Product Change Notification

Change Notification #: 107368 - 00

Change Title: Intel PRO/1000 XF Server Adapter, PWLA8490XFG2P20 MM#856113 (OEM generic Eldridge) and PRO/1000 F Server Adapter, PWLA8490SXG1P20 MM#826170 (OEM generic Kodiak II)

Date of Publication: March 19, 2007

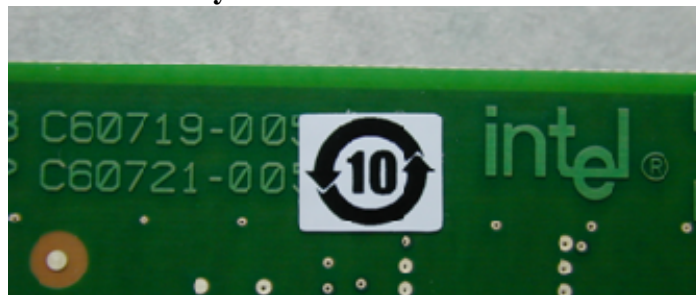
Intel will add a PRC Environmental Friendly Use Period (EFUP) label on the Network Adapters:

- PRC requires this EFUP label for control of Pollution caused by Electronic Information Products.
- This EFUP label will be placed on the secondary side of the adapter, **as shown in the pictures below**, the EFUP label could be placed in a slightly different location based upon space constraints. This label will include a 10 year use period for all Desktop adapters, or a 20 year use period number for all Server adapters.
- The products shown in the Affected Products Table, within this PCN notification, will include this new EFUP label.

Picture of Large, Small and Med sized labels (example shows size of labels only, not exact placement)

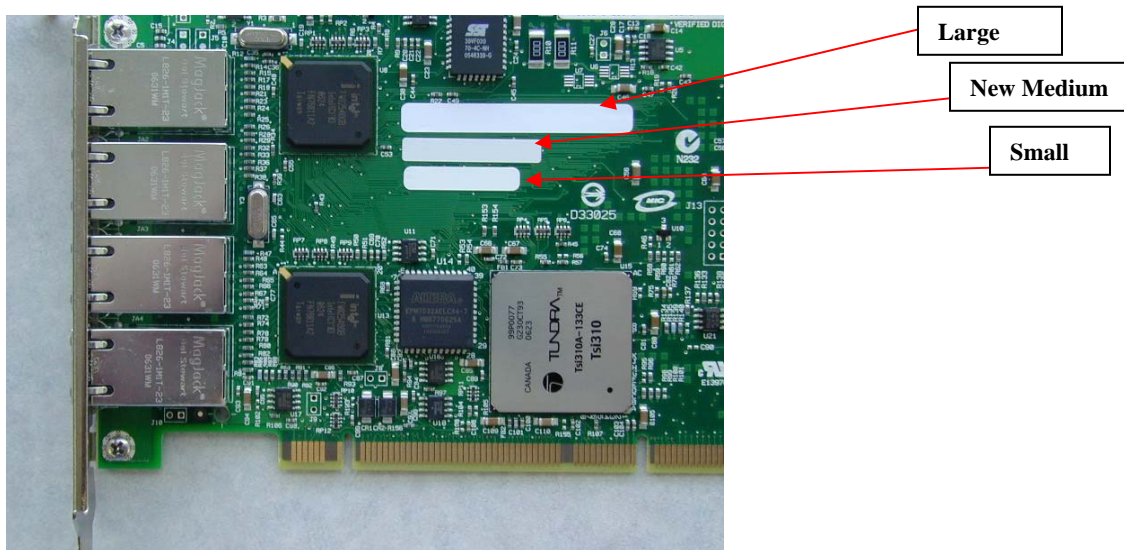
- The 3n1 label, which is placed on the primary side of the adapter in the upper right hand corner, will change from either a Large label size of 2" x .25" or Small label size of 1" x .20" to a Medium label size of 1.2" x 0.20". This will not affect the label data in any way. **Please see picture below.**
- We recommend all customers enable their bar code scanners to Scanning Code 93 for the new Medium sized label.
- The products shown in the Affected Products Table, within this PCN notification, will include the new Medium 3n1 label size.
